FINAL ENVIRONMENTAL IMPACT REPORT JANUS SOLAR AND BATTERY STORAGE PROJECT

**COUNTY OF COLUSA
COMMUNITY DEVELOPMENT DEPARTMENT
220 12th Street
Colusa, California 95932
State Clearinghouse No. 2024061043
November 26, 2024**

**JANUS SOLAR AND BATTERY STORAGE PROJECT
FINAL ENVIRONMENTAL IMPACT REPORT
TABLE OF CONTENTS**

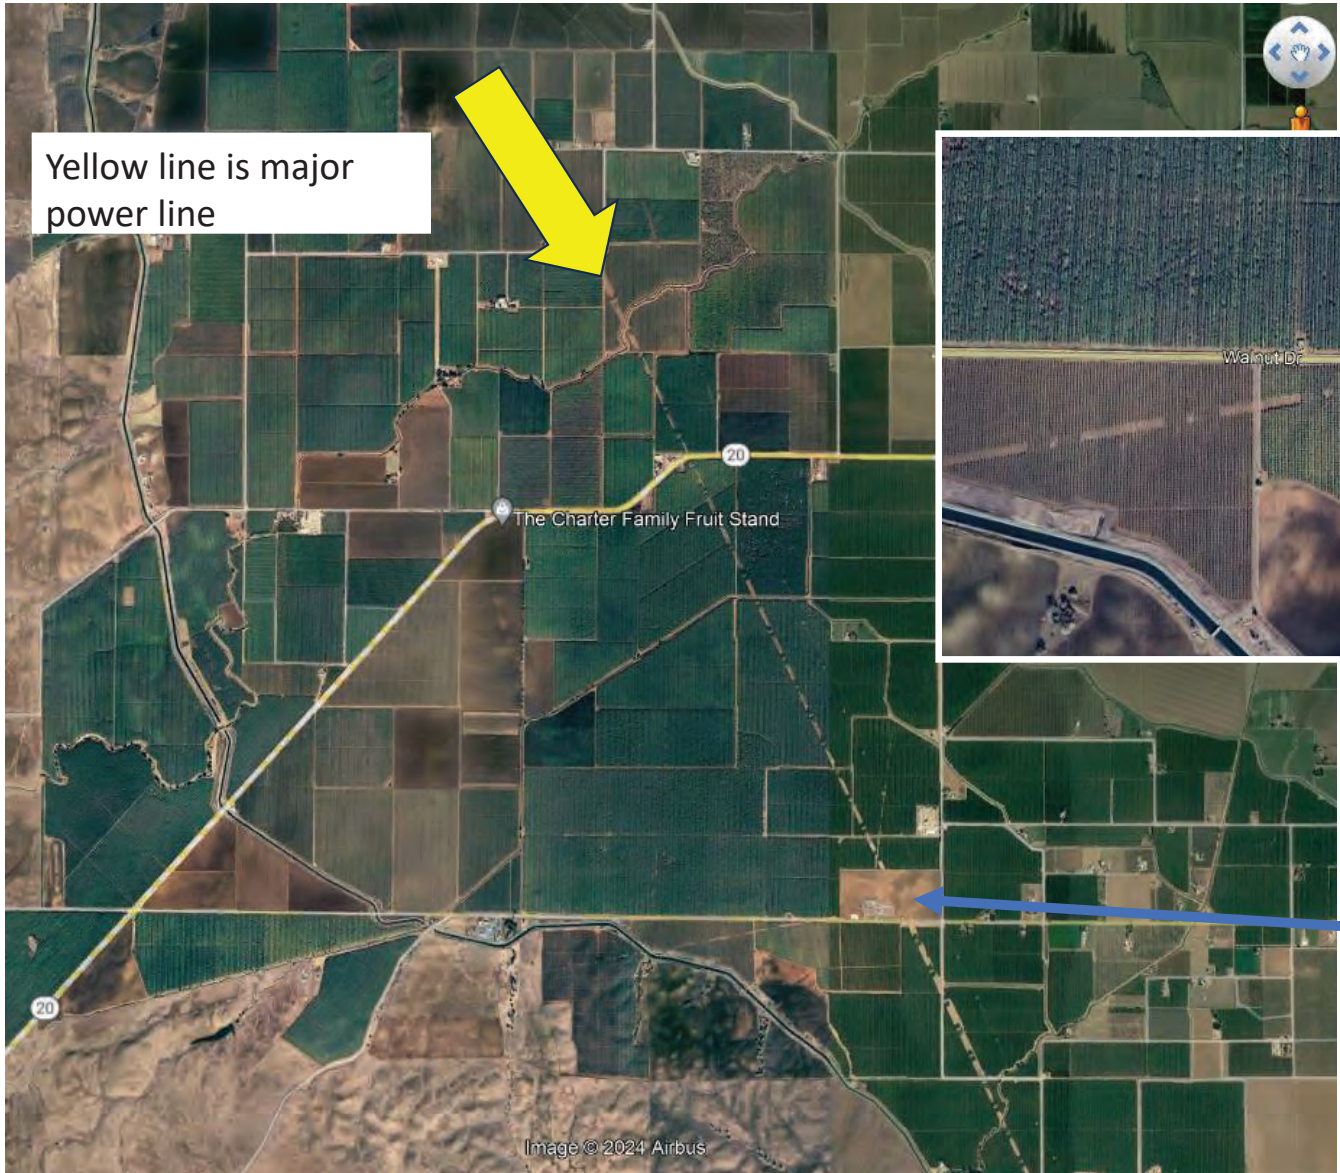
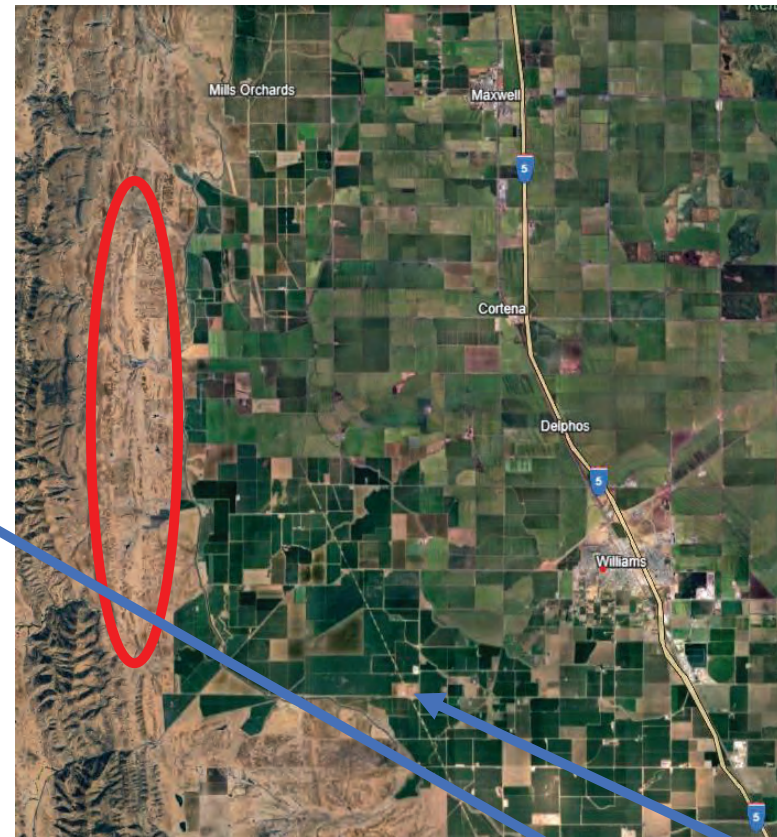
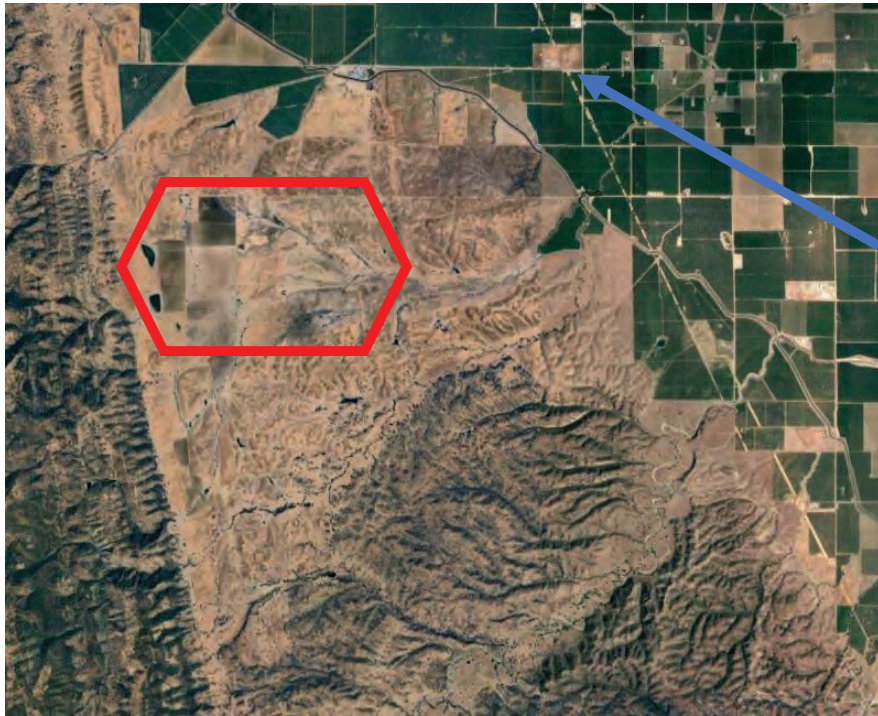
Impact of Solar to Mount Orab, OH, from 2017 to 2022; LESA model in DEIR does not account for solar & ZOI.

Last update (correction) to LESA model Appendices A and B (**dated 2011**) per [Conservation.ca.gov](https://www.conservation.ca.gov/); Does the DEIR modeling account for changes to solar development; what and how do factor weight impact analysis, ZOI, and are they current and being applied correctly?

- Any Permit, County General plan or ordinance needs to anticipate & correctly model impacts of utility size (large scale) solar developments occurring, particularly if there is a main electrical conduit, substation and/or Gen-tie in nearby.

Red outlined areas may become solar lands and no longer farmland due to zone of influence by initial >600 ac solar facility and Gen-tie in; could also include south of displayed location below.
